CITY OF HAYWARD AGENDA REPORT

Meeting Date 4/14/05
Agenda Item 3

SUBJECT: **Zone Change No. PL-2004-0418 & Vesting Tentative Tract Map 7554/PL-2004-0417 –Arlene Utal for Chabot Estate Homes (Applicant)/ Greg Silva (Owner) – Request to Change the Zoning From a Single-Family Residential (RS) District to a Planned Development (PD) District and Subdivide 2 Acres to Build 11 New Homes and Renovate the Existing Home**

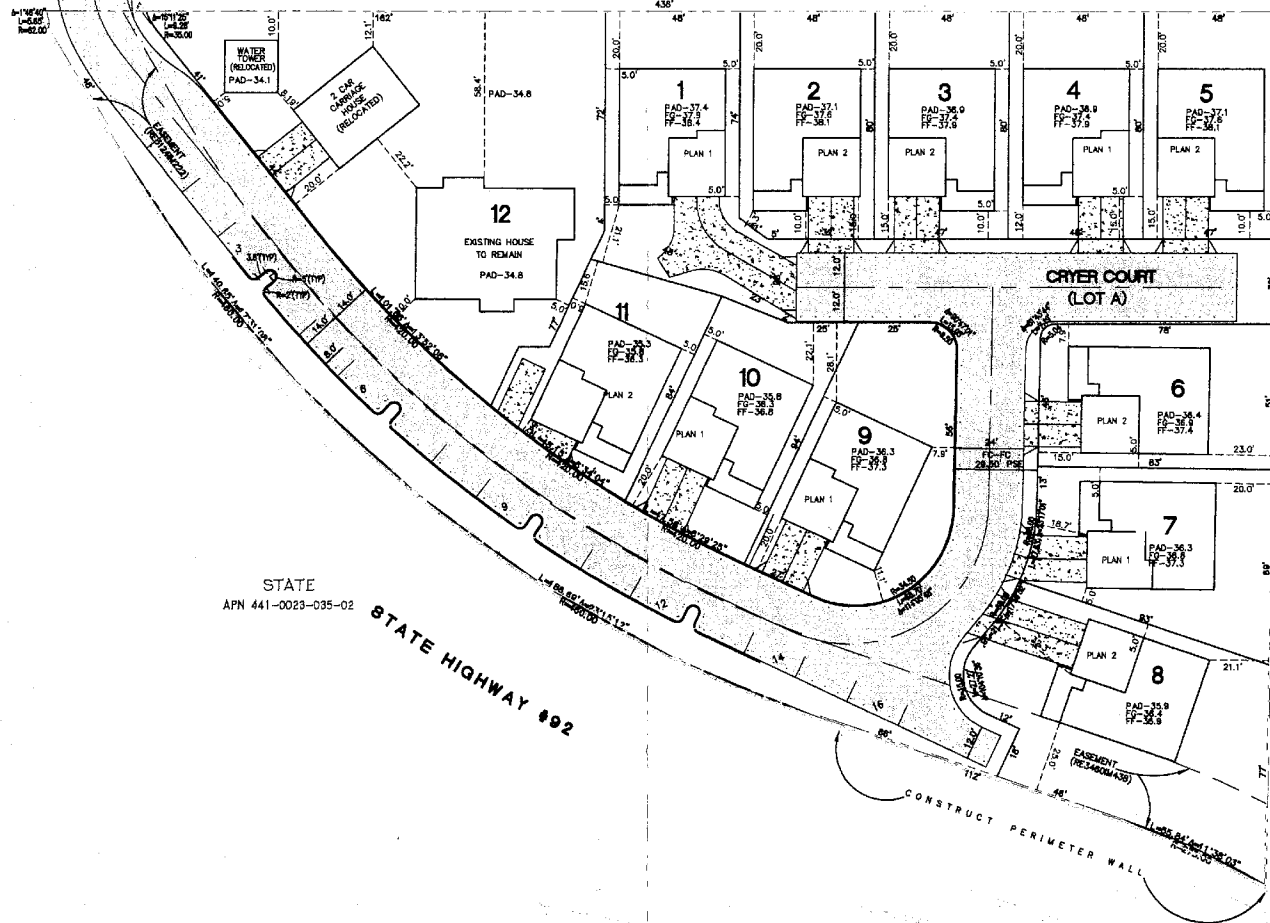
All proposed homes would be separated by at least 10 feet and all structures meet the setbacks required by the RS zoning with a few exceptions. The proposed house on Lot 5 would be only 5 feet from the side property line where 10 feet would normally be required, however this property line abuts the rear of the church where there are accessory structures scattered along the fence, so the reduced setback is not expected to negatively impact the adjacent property. Also, as discussed above, Lots 10 and 11 are designed with rear yards with less than the 20-foot setback required by the RS zoning and Lot 11 has only a 5-foot front yard setback where 20 feet is required.

Two story homes are being proposed under the dripline of three other trees (labeled as 18, 19 and 20). The pruning that would be necessary to build the homes would create a tree canopy unacceptable to the City. Although the trees, in the short term, might survive the major pruning, they would look unnatural in form and the long term damage to such trees is difficult to assess. In the past, the City has received complaints from neighbors when this type of extensive pruning

occurs. City Design Guidelines discourage the construction of structures within the dripline of existing trees. It should be noted that these three trees are located along the western property line of the project site and have canopies that extend into lots on Adrian Avenue. Staff recommends any development of the site avoid construction within the dripline of the trees.

The developer is proposing to construct a grassy swale along the soundwall to meet Clean Water Program requirements to filter stormwater before it enters the City system. This swale must be designed to meet accepted standards for width, depth and flow capacity to ensure runoff is filtered properly, and that runoff from large storms will be contained within the swale.

The City requires trees to be planted at the perimeter of the site, but the trees along the sound wall would need to be planted in the swale to provide adequate clearance from the wall. Given the width of the planter and swale, the trees when mature would impede the flow of runoff. The swale and bench would have to be wider to accommodate both the trees and provide the necessary slope and depth for stormwater. Finally, the landscape bulb-outs along the sound wall do not meet the minimum interior width of 5 feet required for street trees. The swale, perimeter and street trees could be accommodated, but would result in the elimination of the visitor parking along the private street. Staff recommends the swale be made larger without losing the visitor parking.
